PHILADELPHIA ELECTRIC COMPANY

February 13, 1981

Re: Docket Nos. 50-277
50-278

In a telephone conversation with D. Verrelli and R. White of the NRC in November of 1980, two items were discussed concerning our November 13, 1980 submittal on the "Adequacy of Station Electric Distribution Systems Voltages". We were asked to respond formally to these items. The concerns raised by the NRC and our responses are listed sequentially below.

FIGURE 2

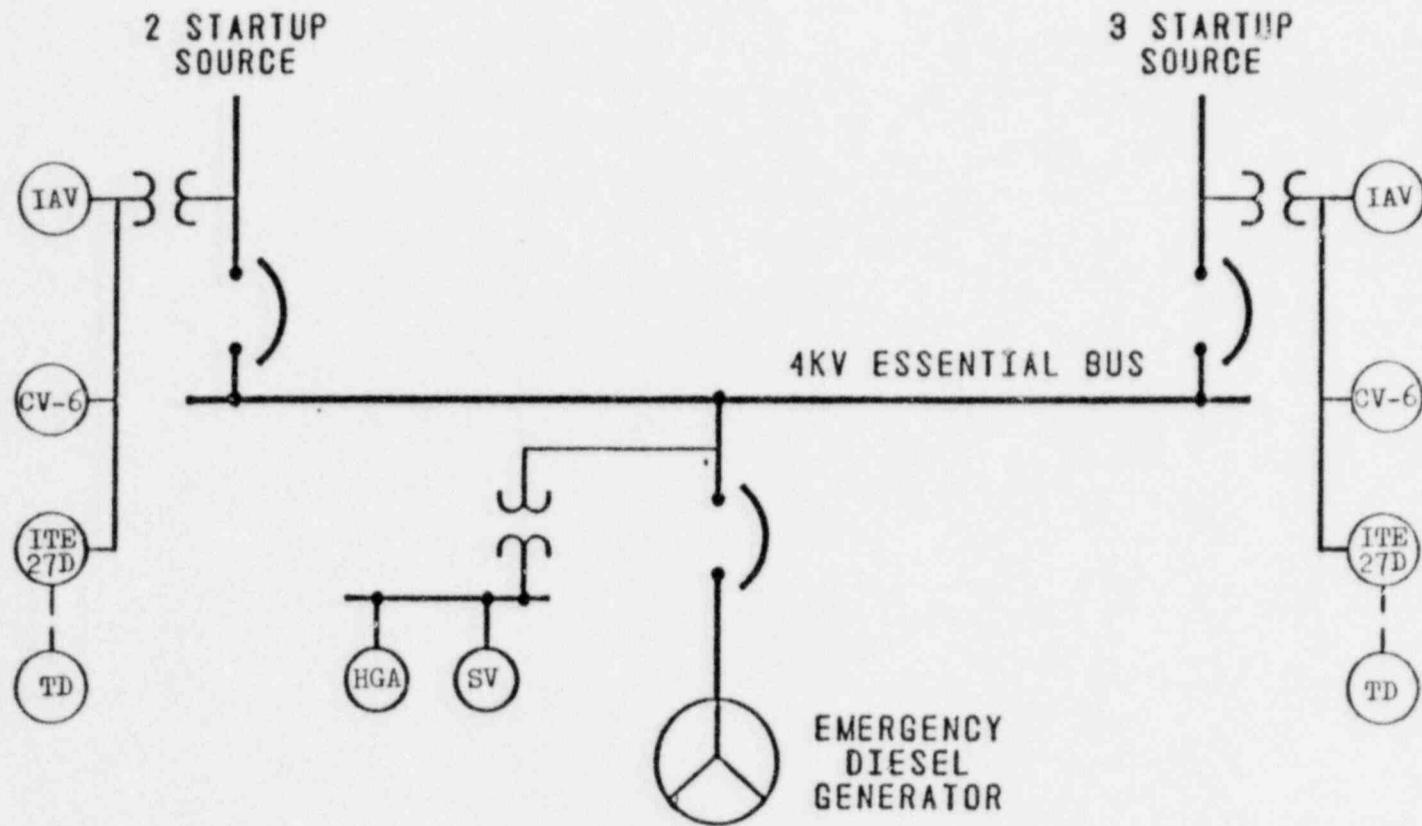
The proposed voltage protection does not include coincidence logic.

We do not believe there is a need for coincidence logic for our proposed voltage protection scheme at Peach Bottom. The addition of coincidence logic would not add significantly to the reliability or availability of the emergency buses.

There are four emergency buses per unit at Peach Bottom. The attached Figure 2 from our previous submittal shows a typical emergency bus with our proposed degraded voltage detection relays. Presently, two of the four buses per unit are supplied from one of the two startup sources; while the other two buses per unit are supplied from the other startup source. If the voltage on one of the sources drops and remains at a level sufficient to actuate one of the proposed relays, the corresponding feeder breaker will trip open, the load will be shed, and the bus will be transferred to the alternate source if the alternate source voltage is adequate.

For normal plant operation, the failure of one of the voltage detection relays to operate will not cause the loss of an emergency bus because the operating characteristics of the relays overlap such that, for most single relay failures, one of the other two relays in each scheme would operate.

The failure of a relay to operate under degraded conditions would be identified by the transfer of at least three other emergency buses. Only three of the four emergency buses per unit are assumed operable for response to a Design Basis Accident. In addition, the procedures require that the operator analyze the emergency bus control console to assure that all the buses are energized. At this time, the operator can transfer the bus manually at the console if voltage conditions dictate.

There are other noncoincident items involved in the operation and control of each feeder breaker to each emergency bus. There is only one feeder breaker from each offsite source to each emergency bus. There is only one DC control feed to each bus; one set of load shed, transfer and reload logic on each bus; one diesel generator per bus; and only one set of single phase potential transformers installed on each feed to the emergency bus. The single failure of any of these items could result in the loss of the entire bus.

IEEE Standard 603-1980 states "(that the Single Failure Criterion) does not invoke coincidence (or multiple channel) logic within a safety group; however, the application of coincidence logic may evolve from other criteria or considerations to maximize plant availability or reliability." Since the failure of a relay could not cause the loss of the bus, there is no need to provide coincidence logic for the detection relays.
